Access Compliance Report

Public Rights-of-Way

(Curb Ramps)

Intersection ID: 29184	Main Street: CHALKBARK_LN	Cross Street: JADE_GLEN_DR	Location: W
ADA ID: ECE32FCA3D49	Ramp Type: PerpDiag	Initial Pass/Fail: Fail	Overall Compliance: No
Severity Score: 12.5			
Codes/Mitigation Info/Possible Solution		Field Measurements/Component Compliance

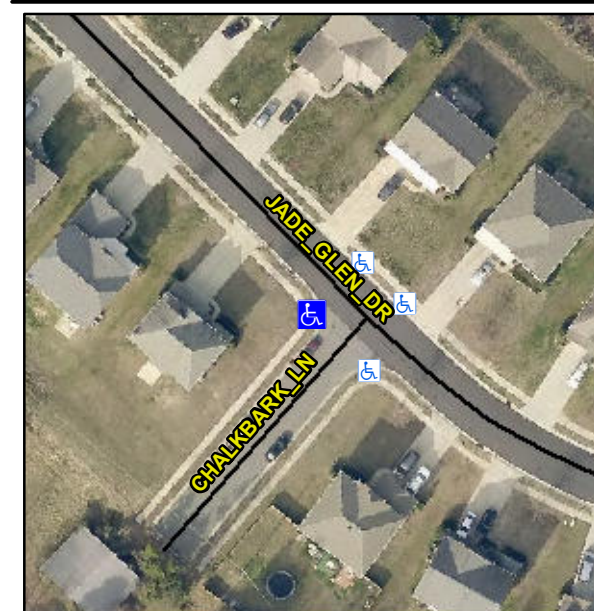
Compliance	Description	Data	Compliance	Description	Data
N/A	Ramp Length (in)	47.5	No	Ramp Slope (%)	10.2
Yes	Ramp Width (in)	48.0	Yes	Ramp XSlope (%)	1.8
N/A	Flare Type LT	N/A	N/A	Flare Type RT	N/A
N/A	Flare Slope LT (%)	N/A	N/A	Flare Slope RT (%)	N/A
N/A	Flare Traversable LT?	N/A	N/A	Flare Traversable RT?	N/A
N/A	Landing Length (in)	N/A	N/A	DWS Provided?	N/A
N/A	Landing Width (in)	N/A	N/A	DWS Contrast?	N/A
N/A	Landing Slope (%)	N/A	N/A	DWS Length (in)	N/A
N/A	Landing X Slope (%)	N/A	N/A	DWS Full Width?	N/A
N/A	Landing Curb? (Y/N)	N/A	N/A	DWS Offset (in)	N/A
N/A	Shared Landing?	N/A			
N/A	Gutter Ponding?	N/A	N/A	Gutter Slope (%)	N/A
N/A	Gutter Lip Ht (in)	N/A	N/A	Gutter X Slope (%)	N/A
N/A	Painted X Walk1?	No	N/A	Painted X Walk2?	No
	X Walk 1 Direction	To SE		X Walk 2 Direction	To NE
N/A	X Walk 1 Width (in)	N/A	N/A	X Walk 2 Width (in)	N/A
	X Walk 1 Slope (%)	1.2		X Walk 2 Slope (%)	2.1
	X Walk 1 X Slope (%)	0.5		X Walk 2 X Slope (%)	2.6

N/A	Ramp inside XWalk1?	N/A	N/A	Ramp inside XWalk2?	N/A
	Road Slope (%)	0.0	N/A	Clear Space?	N/A
	Road X Slope (%)	0.5	N/A	Clear Space to XWalk (in)	N/A
N/A	Any Obstructions?	N/A	N/A	Storm Grate/Utility Hazard?	N/A
	Obstruction Type			Storm Grate/Utility Type	
		N/A			N/A
		Yes		Surface Condition? (G/P)	Good

Remove & Replace Curb Ramp With Two New Directional Ramps or Equivalent.
